Kootenai National Forest
Attn: Over-snow Motorized Travel Plan
John Carlson, Planning Staff Officer
31374 US Highway 2
Libby, Montana 59923-3022
Submitted via project webpage comment link only

Re: Kootenai Over-Snow Motorized Use Travel Plan

Kaniksu OSV Designation Project: Proposed Action: Suitable Snow - March 31 Idaho Panhandle National Forests

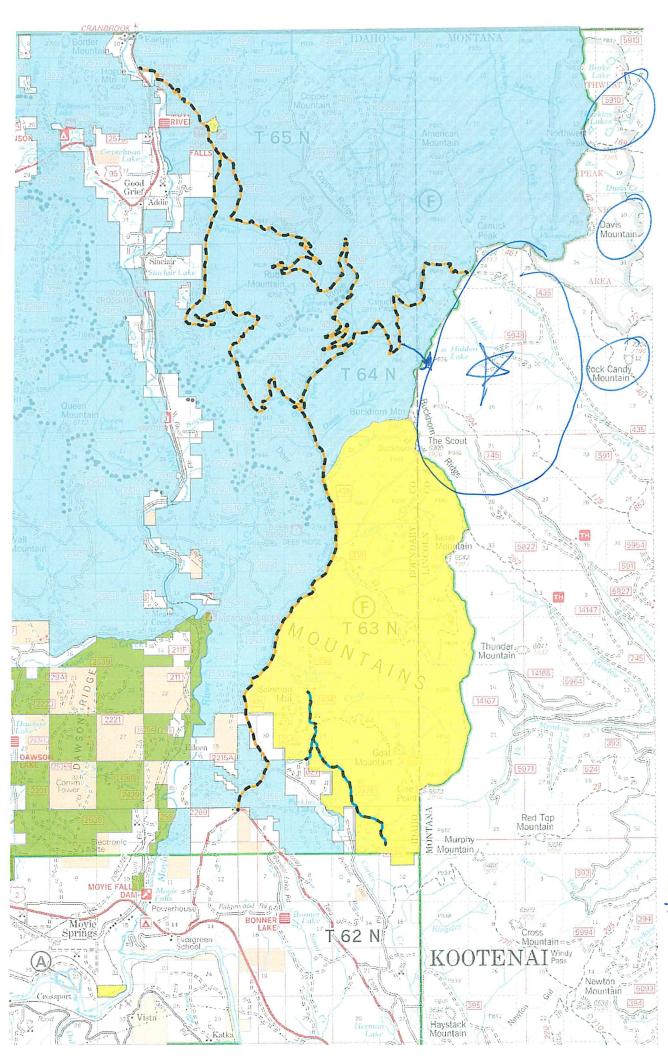
Map 1 (1 page) – the Kaniksu OSV Designation Project map for the pre-April 1 OSV use. The blue and green areas are the areas open to OSV use before the grizzly bear restrictions of April 1. The yellow areas are the areas closed to OSV use year round.

Comment: The plan on the Kootenai National Forest should take into account the plan on the Kaniksu portion of the IPNF and the long standing existing uses of the Kootenai

from the Kaniksu. Consistent adjacent Forest planning and mapping is fundamental to national standards and multiple-use.

MAP 2

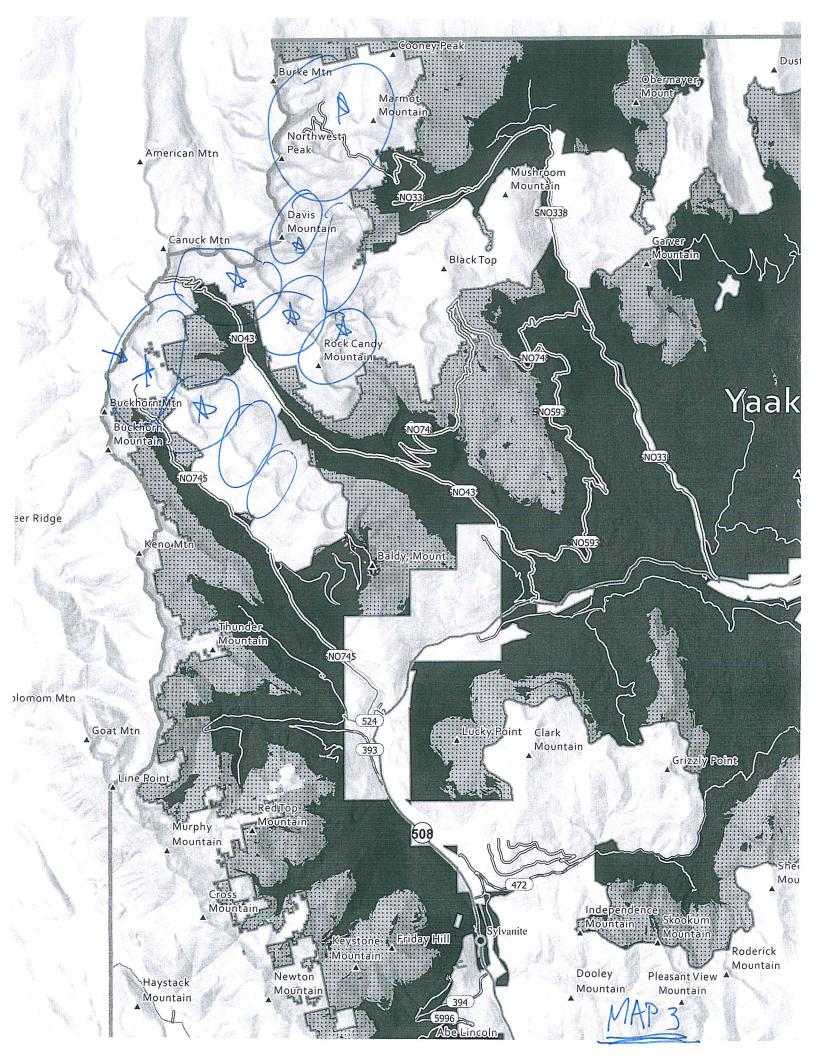
- Map 2 (1 page) this is the portion of the Kaniksu map adjacent to the Three Rivers Ranger District from the Canadian border at the north to approximately Highway 2.
- Map 3 (1 page) this is the portion of the Kootenai Three Rivers Ranger District KNF map from the Canadian border at the north to approximately Highway 2.
- Map 4 (1 page) this is the portion of the Kootenai National Forest Land Management Plan Map of the approximate same area.

Comment: There are significant areas that have been long accessed and used by oversnow vehicles from the IPNF (Kaniksu) which are proposed to be closed on the Kootenai. There is a groomed route for Canuck Basin which hooks into the Spread Creek road and area and upper Hellroaring Creek. There is significant OSV use in the Spread Creek, Hellroaring Creek, Northwest Peaks, Davis Mountain, and Rock Candy Mountain areas from both the IPNF and the Kootenai that should be recognized and preserved in this OSV plan. The Preliminary Proposed Action Map would basically eliminate the vast majority of the existing and desired riding areas. I have consistently used OSVs in these areas since the 1990s. In regards to the minimization criteria, I have not observed any conduct that is identified in the list of 4 objectives. There has not been any damage, harassment, disruption, or conflicts in these areas. There are no documented impacts to justify closure or other restrictions to OSVs. These areas should remain open to provide desired public over-snow vehicle use and enjoyment.

MAP 5

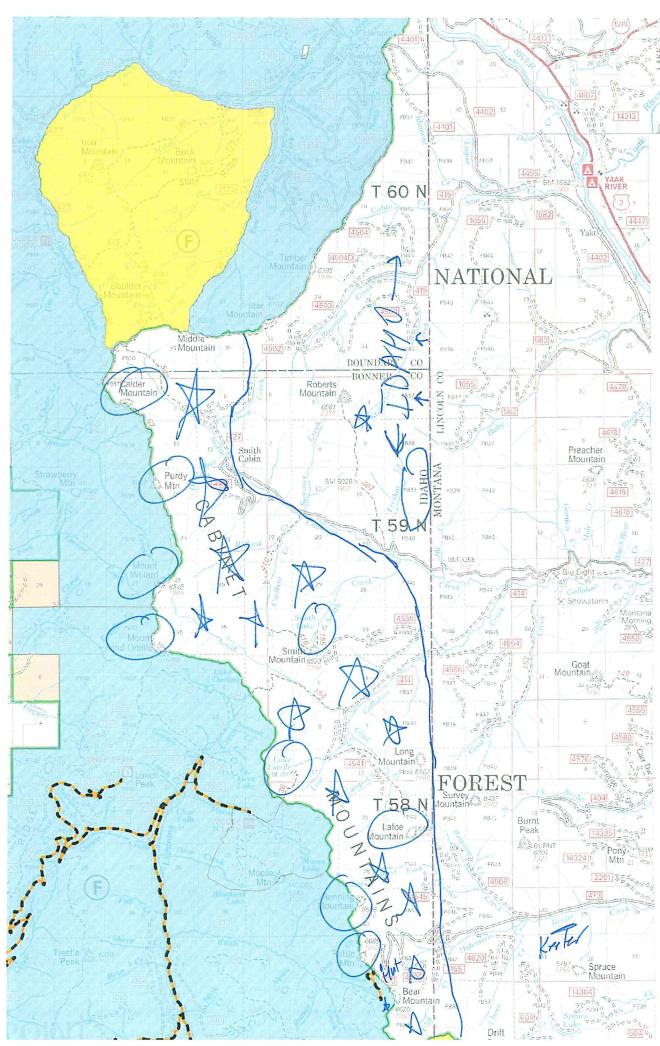
- Map 5 (1 page) this is the portion of the Kaniksu map adjacent to the Three Rivers Ranger District from Highway 2 at the north to approximately Drift Peak (near the north end of the Scotchmans).
- Map 6 (1 page) this is the portion of the Kootenai Three Rivers Ranger District KNF map that has been labelled (erroneously) as all being the "Keeler Area." The Keeler Area is at the southern end based around the Keeler Creek Road Warming Hut and adjacent areas on the IPNF (Kaniksu) in the head end of Rattle Creek. The middle area is the "six lakes" area and the northern end is the Callahan/Mt. Pend Oreille and Willard/Purdv/Calder areas north.
- Map 7 (1 page) this is the portion of the Kootenai National Forest Land Management Plan Map of the approximate same area.

Comment: There are significant areas that have been long accessed and used by over-snow vehicles from the IPNF (Kaniksu) which are proposed to be closed. These areas provide diverse OSV terrain and opportunities from beginner to extreme riders and for snowmobilers and snowbikers. These lands are physically located in the State of Idaho and share a common divide. There is a groomed route to the Moose Lake trailhead that provides for access to the Lightning Creek Warming Hut and the "six lakes area" consisting of Moose Lake, Blacktail Lake, Lake Estelle (on the Kootenai), Gem Lake, Lake Darling, and Smith Lake (on the Kootenai). This area also includes the north and

south forks of Callahan Creek, significant portions of which have been burned (whether old or new fires), and Mt. Pend Oreille. This area also includes the access from the Warming Hut at Keeler Creek Road on the Kootenai (physically located in the State of Idaho) from Rattle Creek, East Fork of Lightning Creek, and through Benning and LaFoe Mountain. There is significant OSV use in all of these areas spanning from north of Calder Mountain all the way down to Drift Peak from the Kaniksu Forest side. These should be recognized and preserved in this OSV plan. The Preliminary Proposed Action Map would basically eliminate very significant connecting areas and routes for the Kaniksu, as well as destination riding areas on the Kootenai. I have consistently used OSVs in these areas since the 1990s. In regards to the minimization criteria, I have not observed any conduct that is identified in the list of 4 objectives. There has not been any damage, harassment, disruption, or conflicts in these areas. There are no documented impacts to justify closure or other restrictions to OSVs. These areas should remain open to provide desired public over-snow vehicle use and enjoyment.
